OPL1000 A1 Module

Title		
History		
Size A	Document Number <Doc>	Rev V1.1
Date:	Monday, April 01, 2019	Sheet 1 of 2

Title			
OPL1000_A1_Module			
Size	Document Number		Rev
B	<Doc>		V1.1
Date:	Monday, April 01, 2019	Sheet	2 of 2

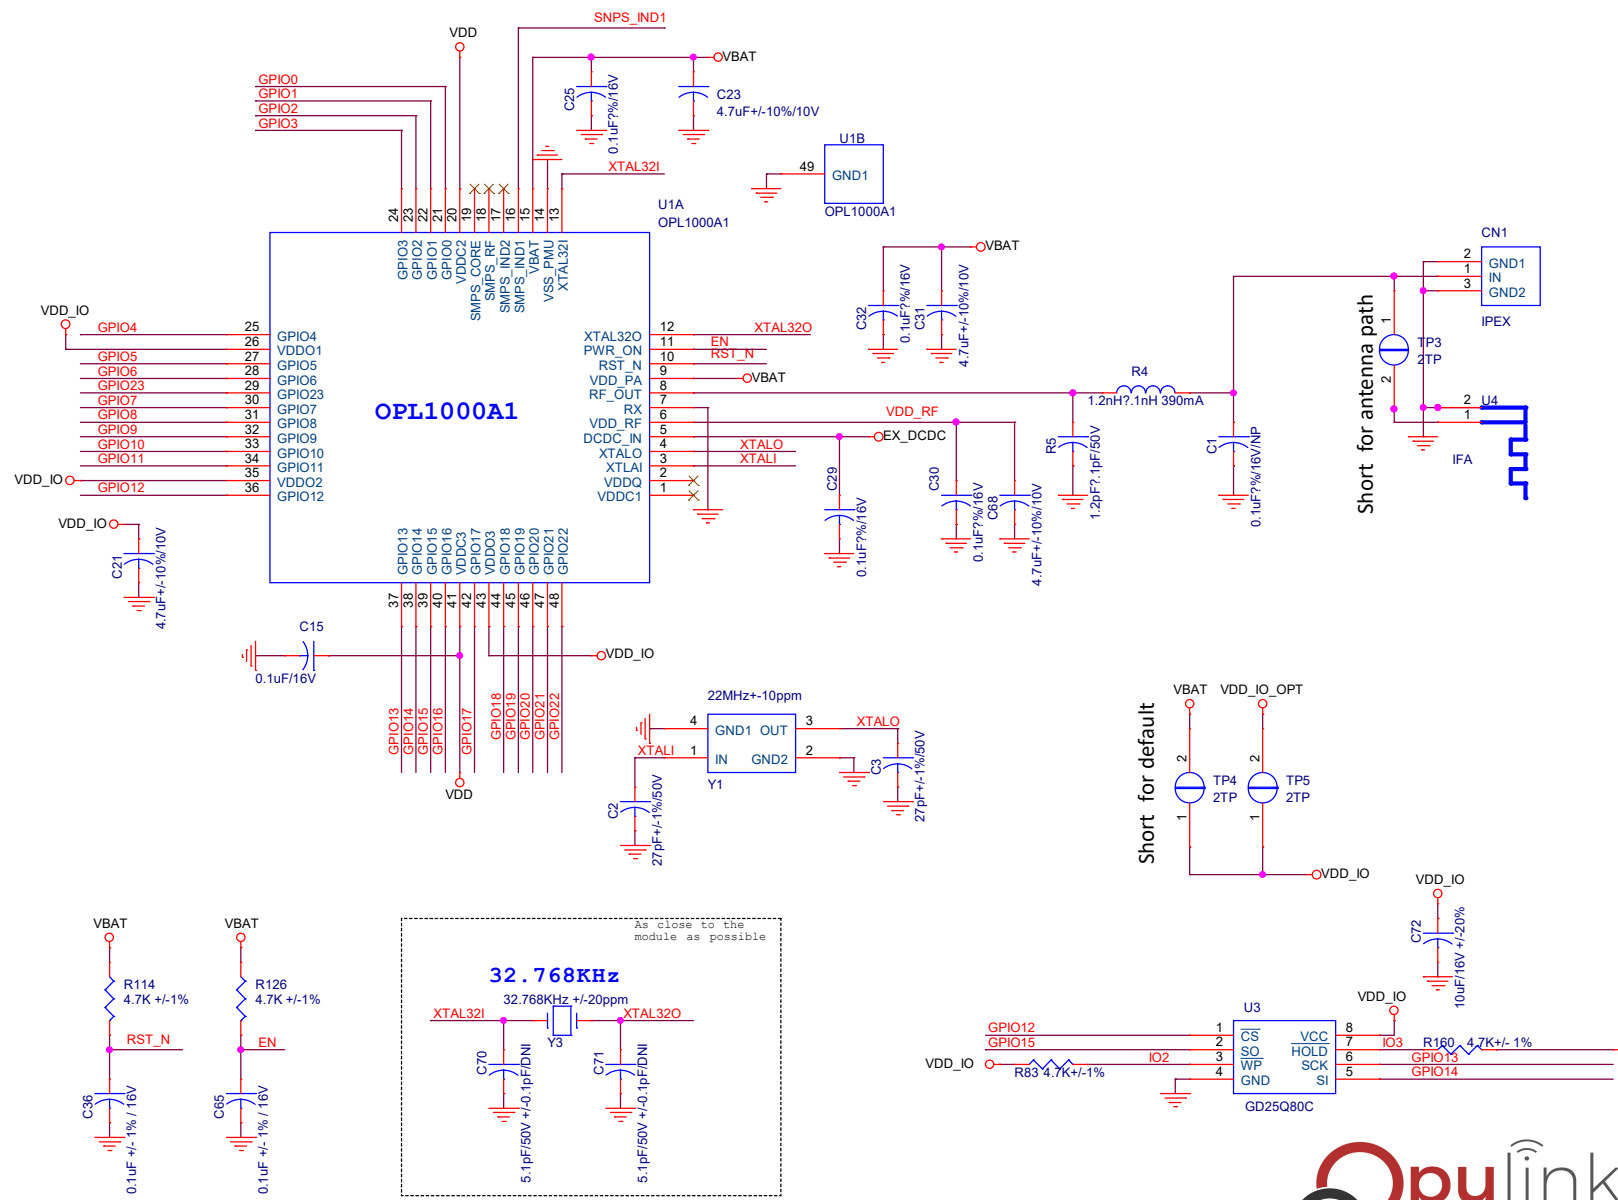
Date	Description
2018/01/23	Initial
2018/02/07	1. move out flash, 32K XTAL, C24
2018/06/15	1. Change to A1 version
2018/09/10	1. C26,C27 C28 DNI 2. Add C68, C69 L3 CN1 3. remove R3 R6 4. C14 change to 4.7uF 5. Add pi circuit on pin19,pin20
2018/10/29	1. Add Flash, 32K XTAL, RST, EN circuit
2018/11/08	1. remove C18,R82,R87,R88 (Flash part) 2. remove C20,C16, change C21 to 4,7uF 3. remove C18, change C72 to 10uF 4. remove D1,D2,C28,C26,C27 5. Change 32.768 XTAL 6. Change C70,C71 to 5.1pF
2018/12/03	1. remove C67 (Buck FB)
2018/12/22	1. Add U6/U7 LDO device 2. Remove TP2 and change TP3 circuit
2019/01/04	1. Reserve C82,C83
2019/02/14	1. R4 change to 1.2nH 2. R5 change to 1.2pF 3. L2,C14, C7 DNI
2019/03/07	1. Remove C78, R168, U7 2. R171 change to 6.2K 3. R167 change to 0 ohm
2019/03/21	1. Reserve L3 component
2019/03/22	1. Reserve L4 component for VDD connection with VDD_RF 2. Add R172 for SMPS_IND1 trace to connect with LDO enable pin 3. Remove C82, c83

2019/04/01	1. Remove L2, L3, C7, C14, C69
